RE: Siemens Automotive Corporation  
FCC ID: M3N-65981411

The following is in response to the comments made on the above referenced Application.

(Fig. 1)

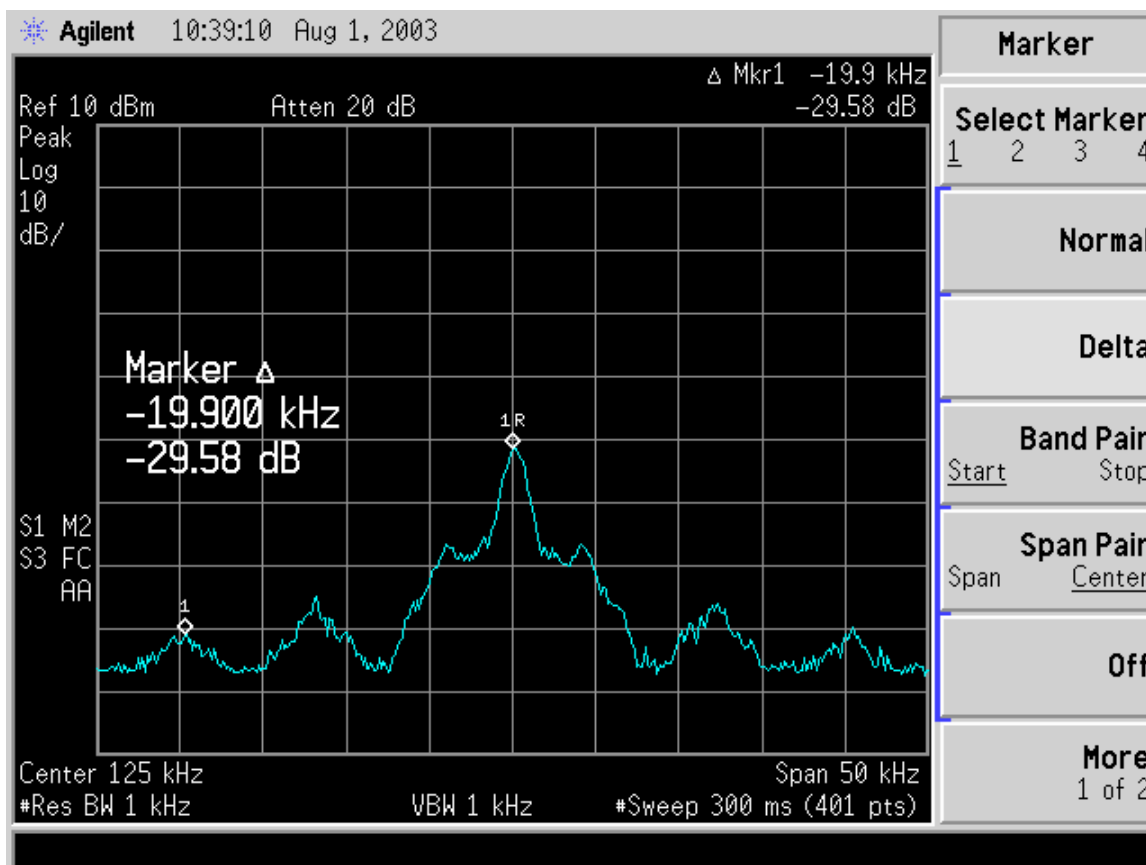
6) According to the bandwidth measured, it appears that part of the bandwidth falls in the 90 – 110 kHz restricted band. Note that the FCC considers all emissions within 26 dB of the fundamental to be modulation products and are therefore part of the fundamental. Therefore all emissions that fall in the restricted band must be < 26 dB below the fundamental, regardless of the power level at the fundamental.

We agree that at 110 kHz the spectrum is down only 18dB (p. 8, Report #415031-167A). Please note that this is the second sidelobe of a  $\sin(x)/x$  pattern, and FCC has accepted the argument that the sidelobes can be considered as spurious and not part of the fundamental emission. Siemens has performed an experiment evaluating the operation of the system with reduced bandwidth that demonstrates the sidelobes are not essential for operation of the system. The experiment write-up is attached.

The maximum lower side lobe (105.1kHz) is 29.58dB down from the center frequency power level. The EasyKey system successfully operated with the suppression of this side lobe. Successful operation was monitored using test software to ensure an appropriate transmission to and response from the CID (customer identification device).
